FED. ROAD DIS. NO.	STATE	FED. AID PROJ. NO.	FISCAL YEAR	SHEET NO.	TOTAL SHEETS
HAWAII	HAW.	I-H3-1(59)	1993	ADD.31	211

STATE OF HAWAII DEPARTMENT OF TRANSPORTATION HIGHWAYS DIVISION	
GRADING NOTES EROSION AND SEDIMENT CONTROL MEASURES	
INTERSTATE ROUTE H-3 F.A.I. PROJECT NO. I-H3-1(59)	
SCALE: AS NOTED	DATE: JUNE 1993
SHEET No. D1 OF 32 SHEETS

ADD. 31

9/30/93	REVISION
DATE	REVISION
STATE OF HAWAII DEPARTMENT OF TRANSPORTATION HIGHWAYS DIVISION	
GRADING AND DRAINAGE PLAN	
STA. 386+00 TO STA. 397+00	
INTERSTATE ROUTE H-3 F.A.I. PROJECT NO. I-H3-1(59)	
SCALE: 1" = 40'	DATE: JUN 1993
SHEET NO. 03 OF 32 SHEETS

DESIGNED BY	DATE
TRACED BY	
QUANTITIES BY	
CHECKED BY

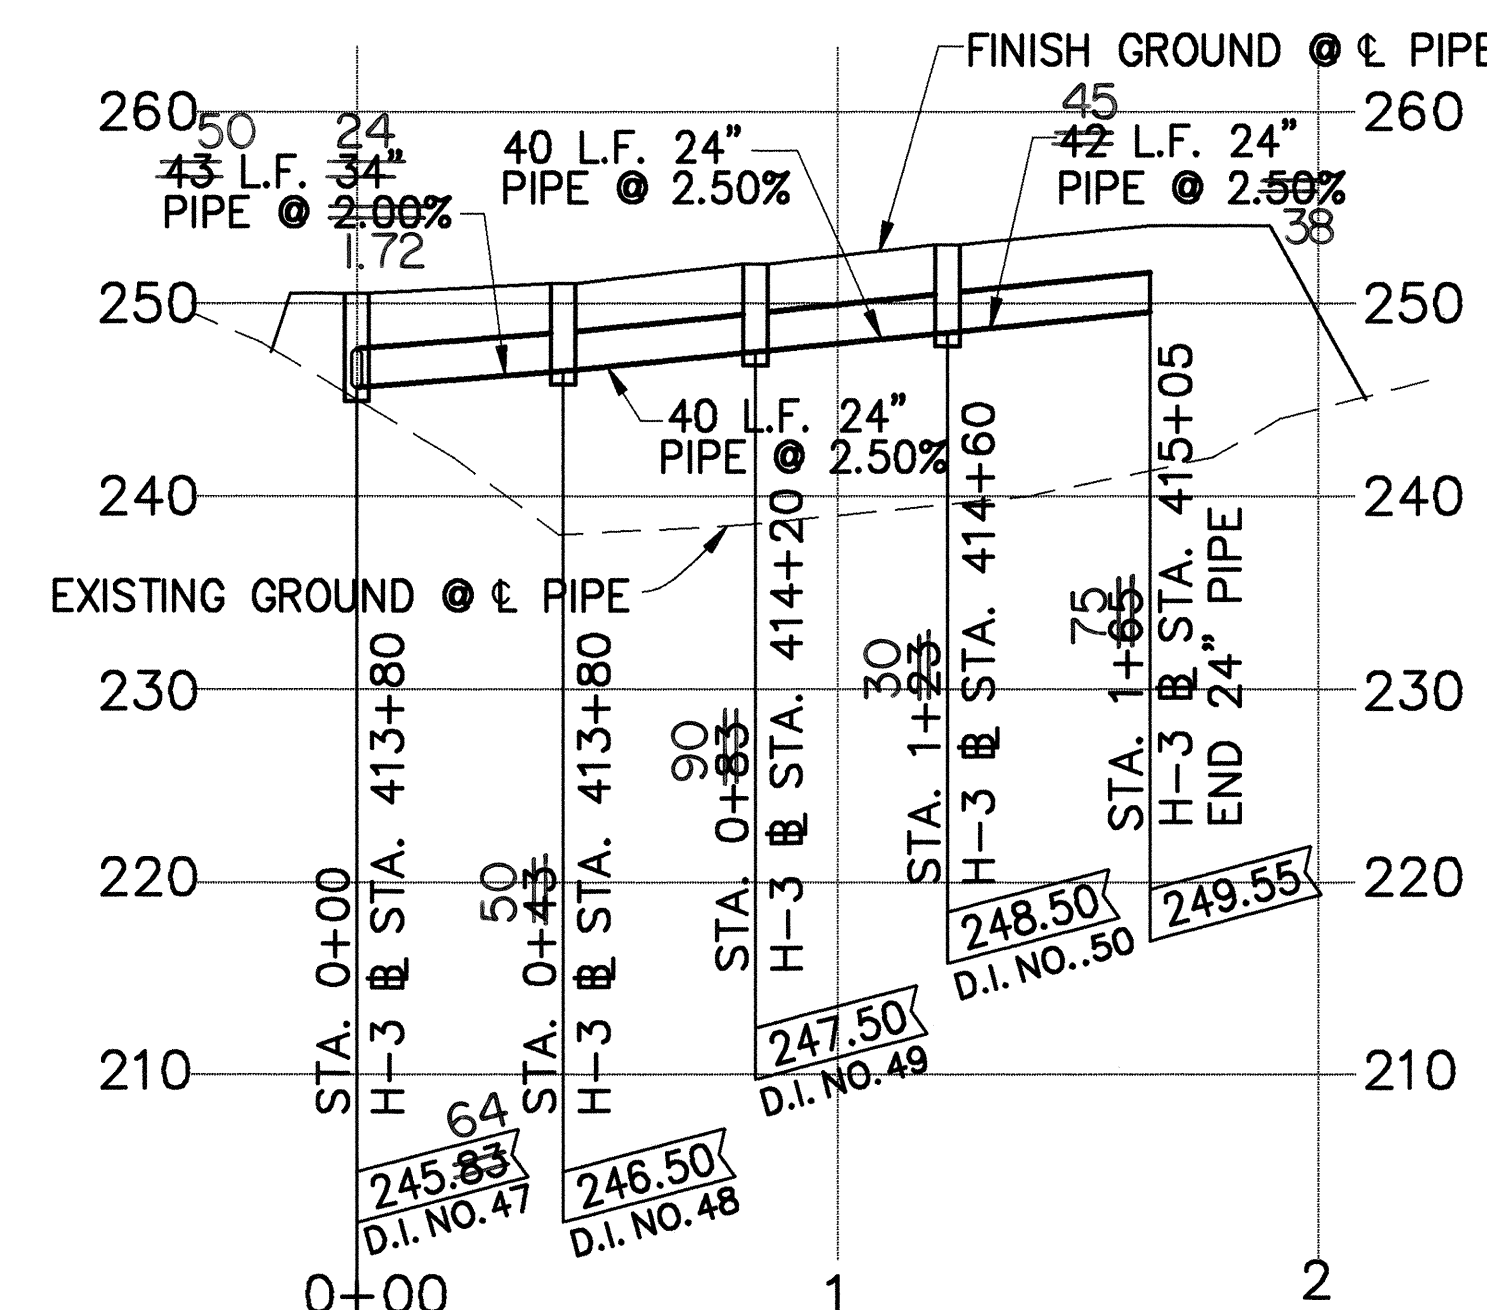
9/30/93	REVISED PROFILE - DRAIN LINE "S", ADDED PROFILE FOR DRAIN LINE "X"
DATE	REVISION

JUNCTION BOX NO. 2 AND 4

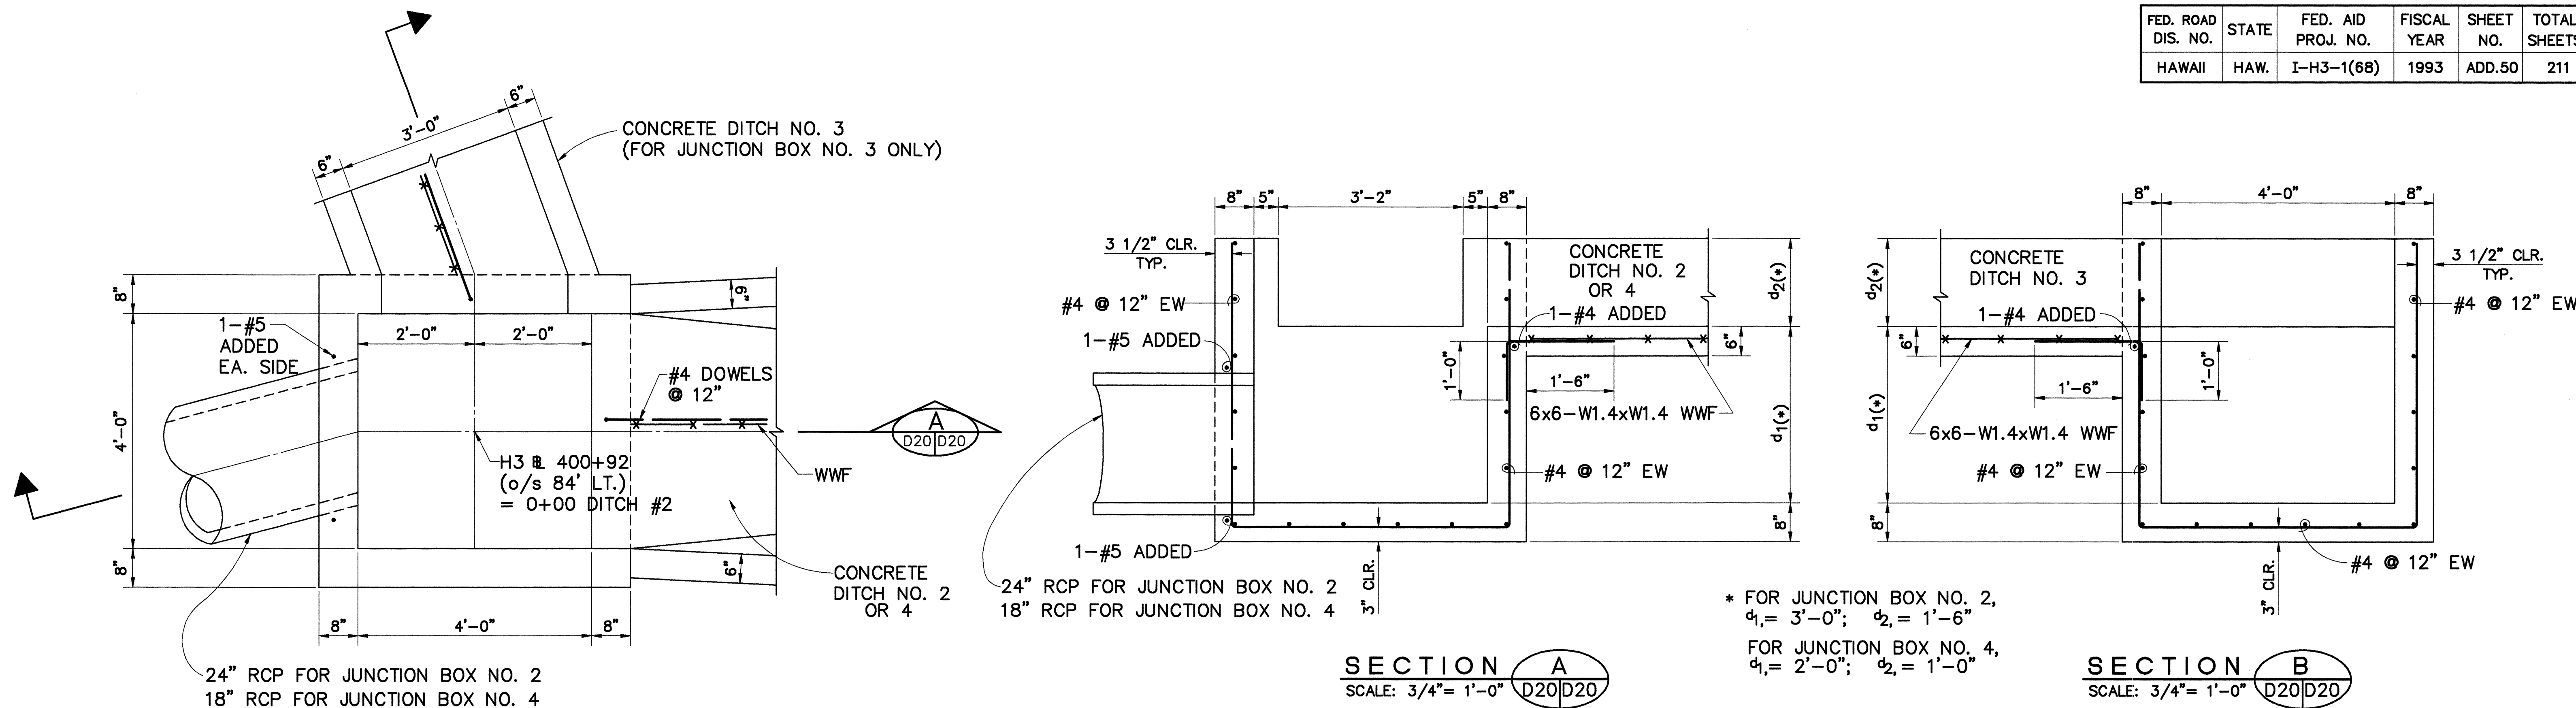
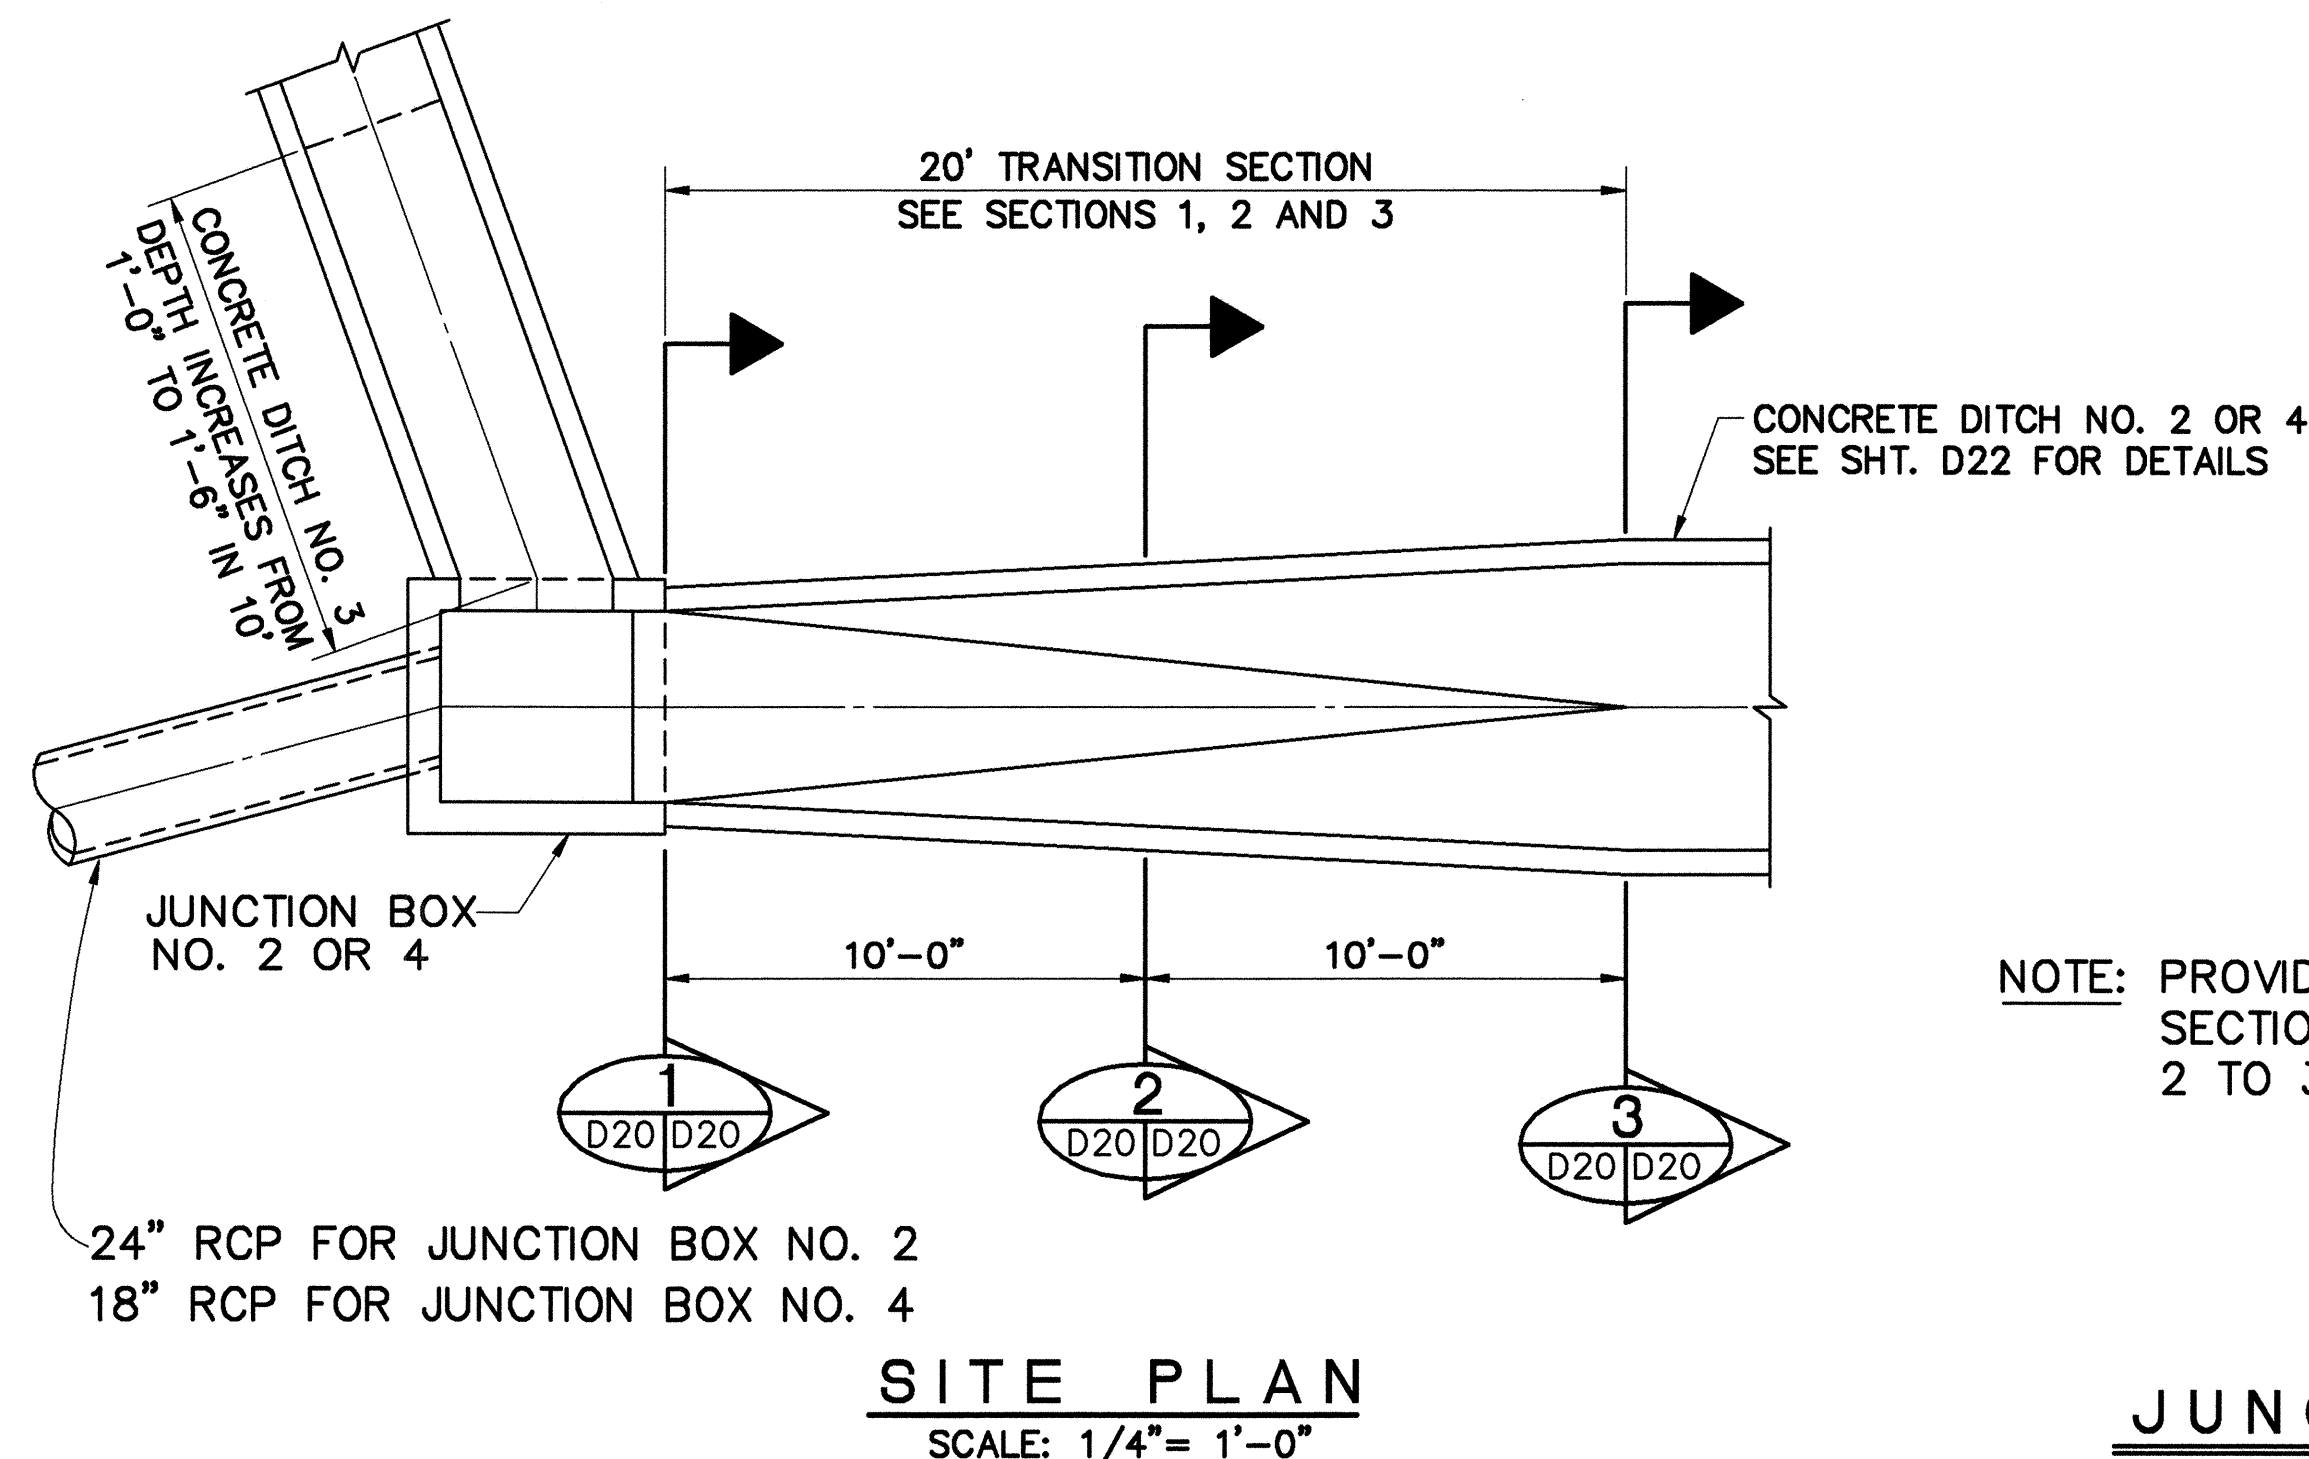
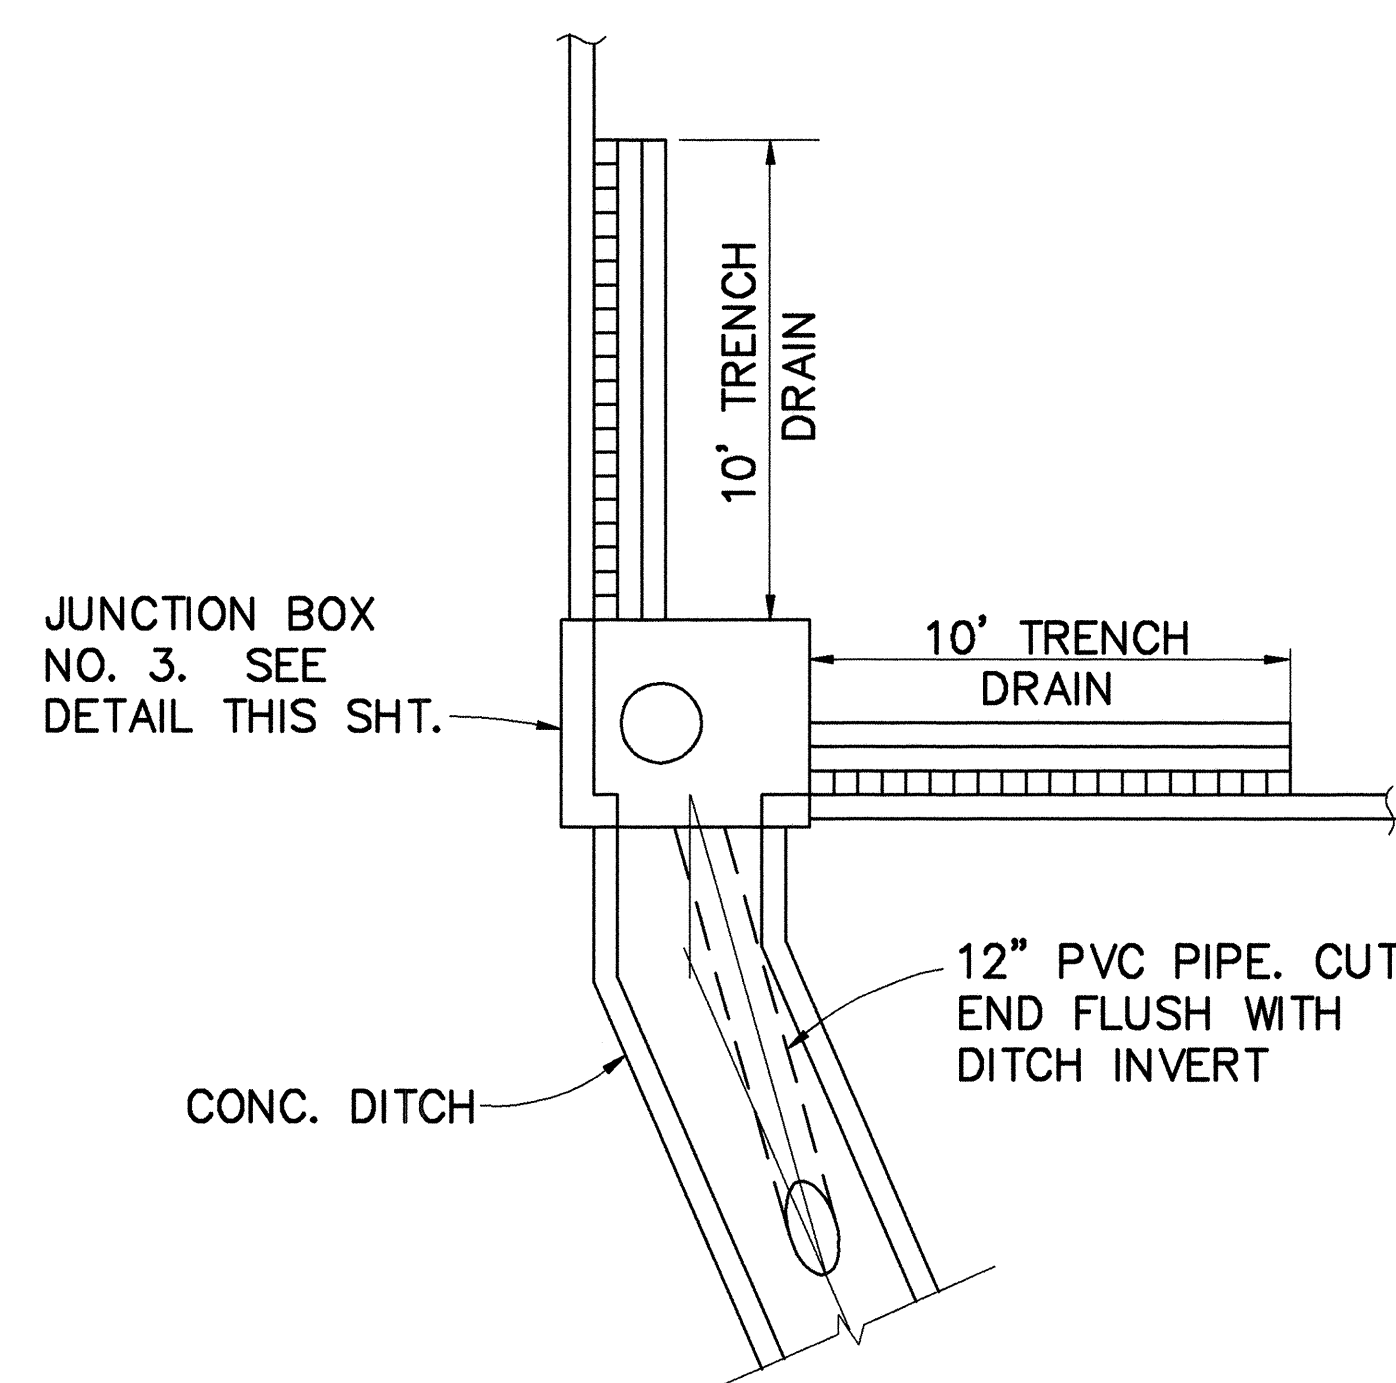
9/30/93	REVISED DETAILS FOR JUNCTION BOX NO. 4.
DATE	REVISION

STATE OF HAWAII DEPARTMENT OF TRANSPORTATION HIGHWAYS DIVISION
DRAINAGE DETAILS
INTERSTATE ROUTE H-3 F.A.I. PROJECT NO. I-H3-1(59)
SCALE: AS NOTED DATE: JUNE 1993
SHEET No. D22 OF 32 SHEETS

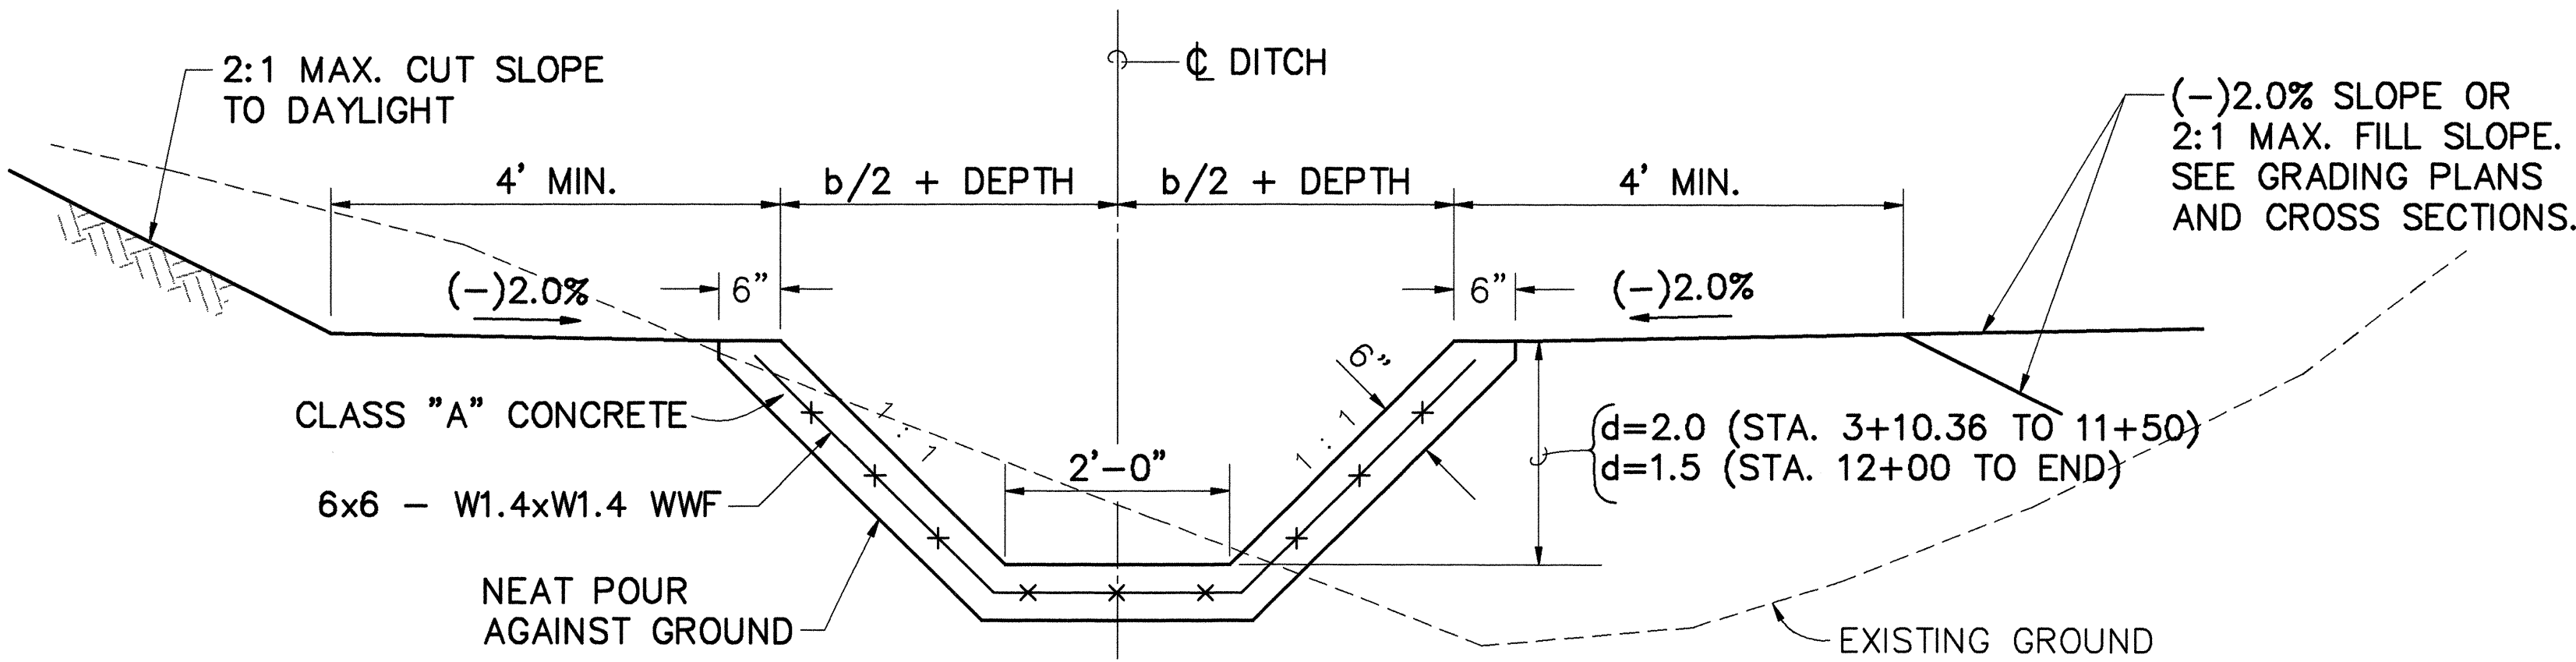
9/30/93	REVISED TYPICAL SECTIONS FOR DITCH NO. 4.
DATE	REVISION
